City of Plymouth Planning Commission

Regular Meeting Agenda

Wednesday, March 11, 2020 – 7:00p.m.
City Hall Commission Chambers

TO: City of Plymouth Planning Commission

SCALE: 1" = 40'
 SHEET NO. C4

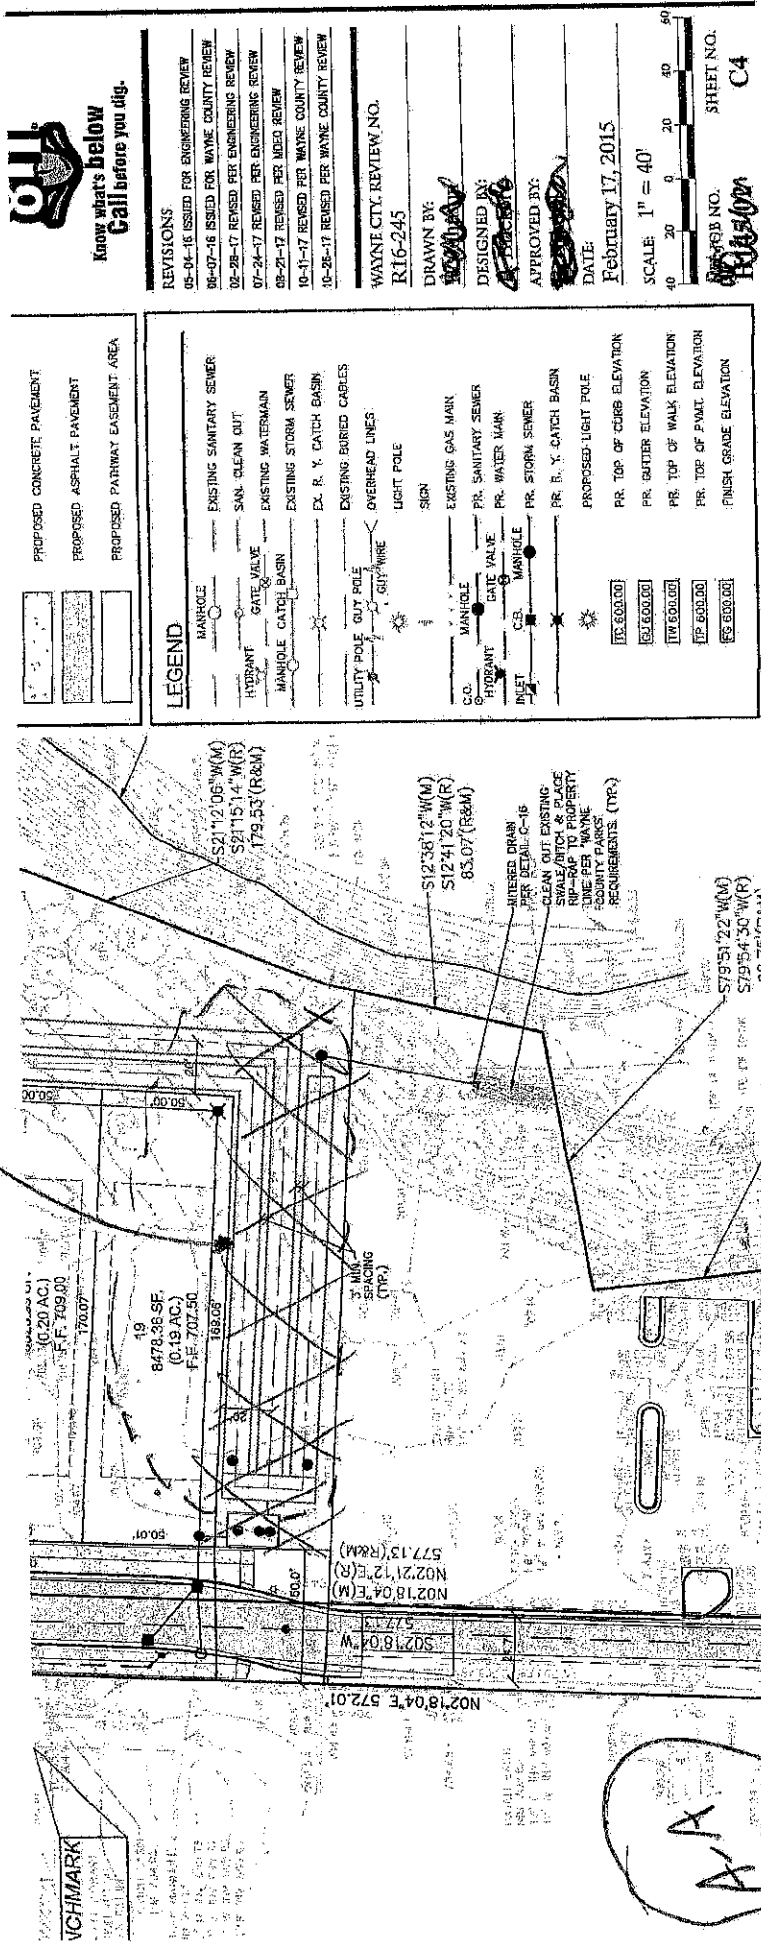
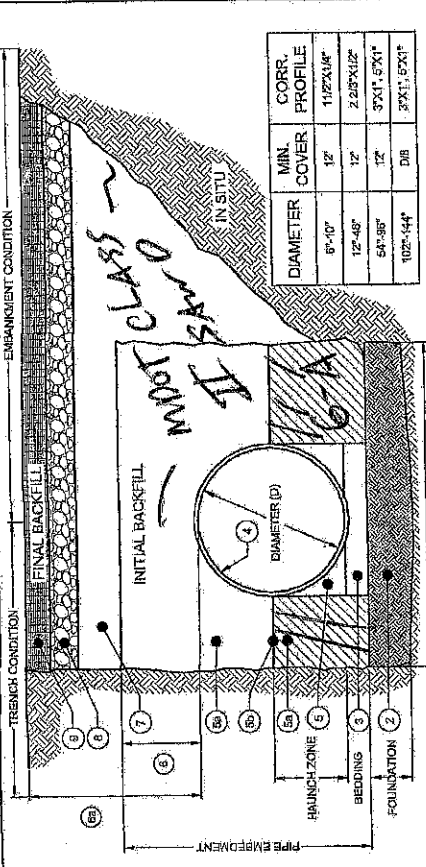
The detention area is shown in the small park, and has been installed. The 20-foot wide easement is not shown on plans. However, a 20-foot dimension is provided. We assume that this is illustrating that there is 20-feet of space allocated for pedestrian movements (comprised of a 7-foot wide concrete sidewalk segment, and 13-feet of open space adjacent to the new parking spaces).

5. Regarding the proposed parking lot:
 - a. The proposed parking lot is located on top of the stormwater structure. The applicant states in their narrative that they will plant trees along the adjacent property line (Lot #19) to screen the parking lot from Lot #19. This isn't possible, as trees can't be planted on top of this underground stormwater structure.
